DR00-0011/76-A-(2&3) Gas Station/Circle K Mini Mart – As approved by the Board of Supervisors on August 4, 2009

Submitted by Staff
#23 + 24
at Board Hearing of 8/4/09

Conditions of Approval

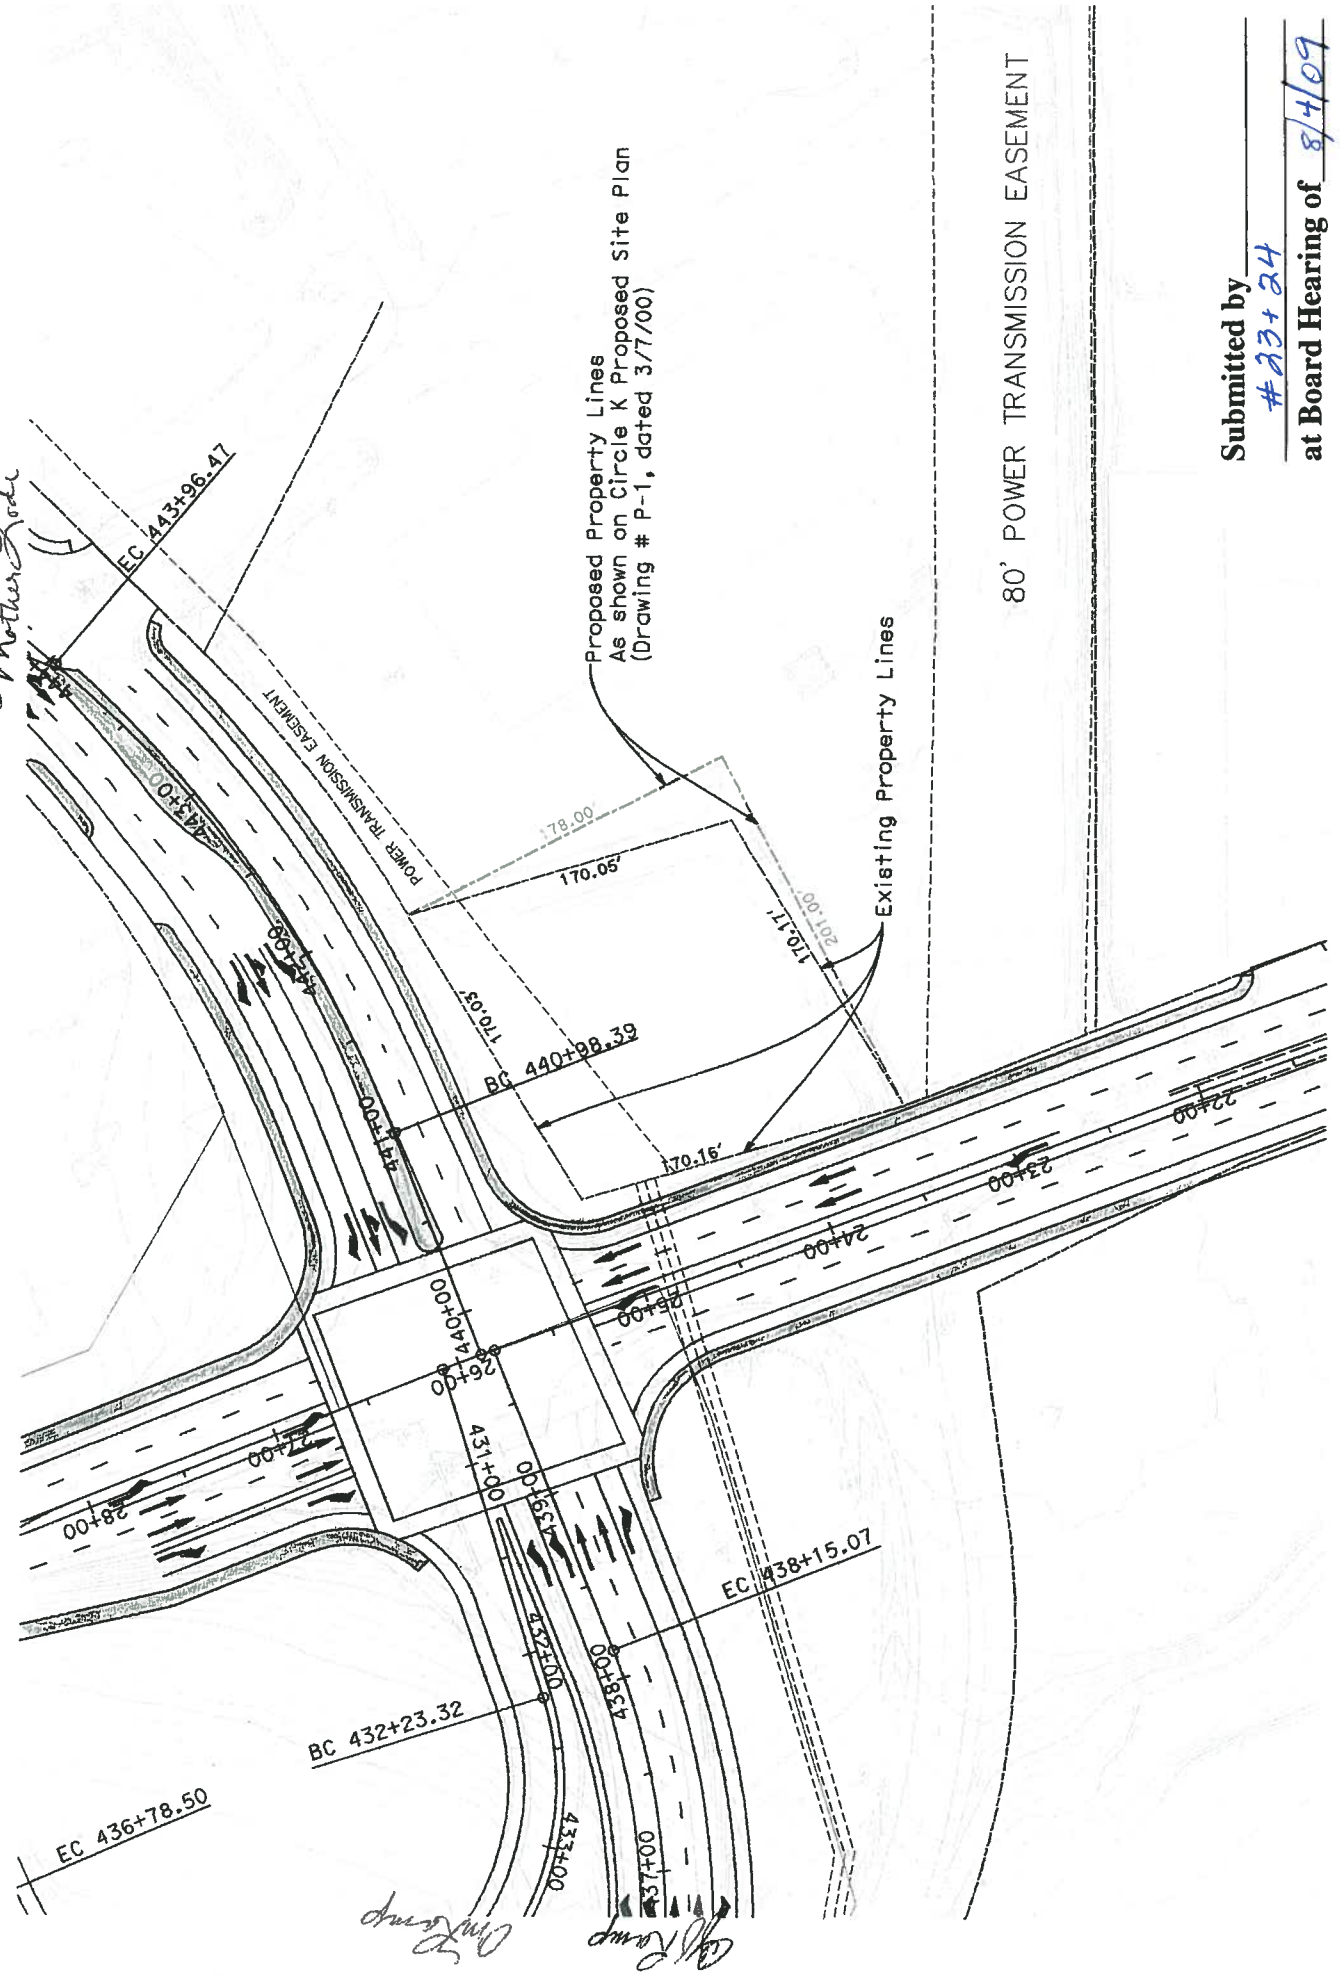
Mother Road

Submitted by _____
 # 23+24
 at Board Hearing of 8/4/09

6' SW
 City - 2.625 Lip of gutter to Ban

11/08 CIP improvements @ 1st St.
